Technical Service Bulletin: TSB220145

Remotely Mounted Fuel Pump Dedicated Lubricating Oil Filter

- QSK60 CM2150 MCRS
- QSK60 CM850 MCRS

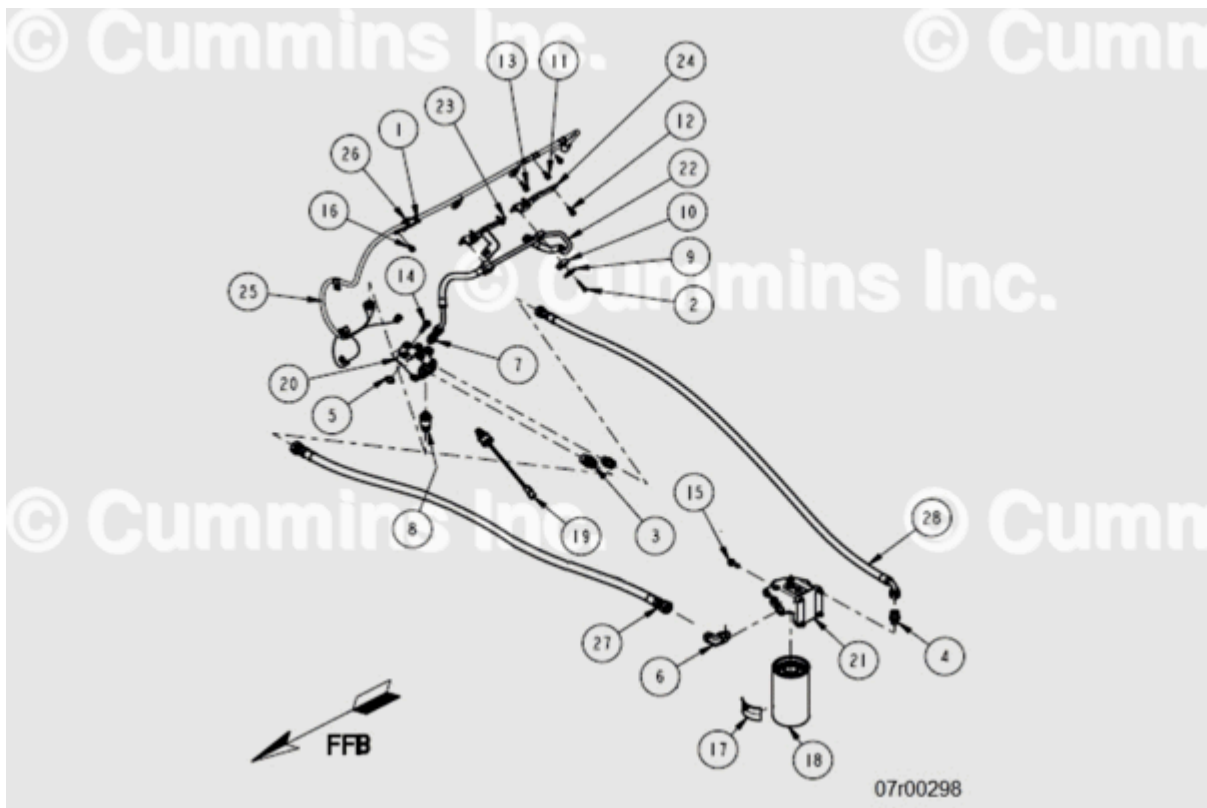
This remote mount dedicated lubricating oil filter has been released to allow customers to fit the fuel pump oil filter independent to the engine.

In some applications there is insufficient space to install the on engine dedicated lubricating oil filter. To enable units to benefit from extra filtration to the fuel pump and improved robustness, Cummins Inc. has released the off-engine version.

This installation should **only** be used in applications where the on engine dedicated lubrication filter is **not** able to be used because of space constraints.
